# ERRATA SHEET

**Date:** 2008 Nov 07  
**Document Release:** Version 1.3  
**Device Affected:** P89LPC922

Figure 1: Flowchart ICP Global Erase

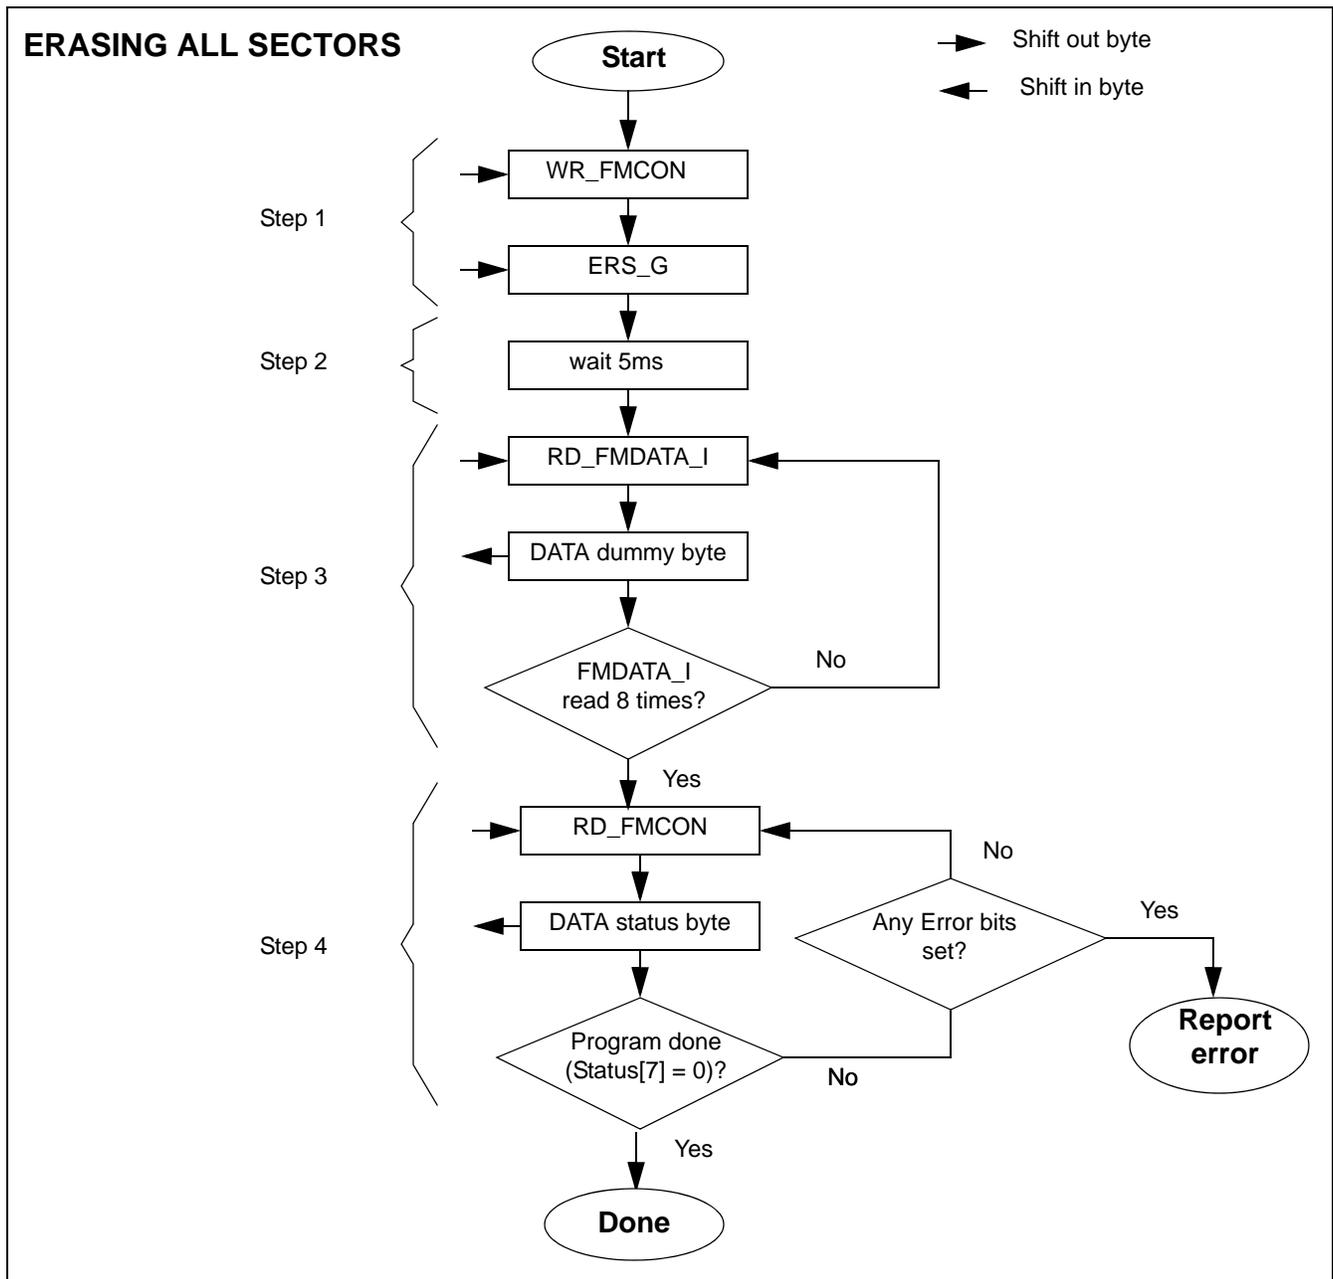
- Introduction:** The LPC922 can be programmed using ICP (In Circuit Programming). One of the ICP functions is the Erase Global command, which will erase the entire chip including the security bytes and configuration information.
- Problem:** When giving the Erase Global command through the ICP interface the LPC922 will not clear the busy flag and stay busy forever.
- Workaround:** The workaround can be done in 4 steps:
- Step 1: Shift out the WR\_FMCON command followed by the Erase Global opcode.
  - Step 2: Wait 5ms.
  - Step 3: Do 8 dummy reads with the RD\_FMDATA\_I command.
  - Step 4: Read FMCON until the busy flag gets cleared.

Please also see figure 1 on the following page.
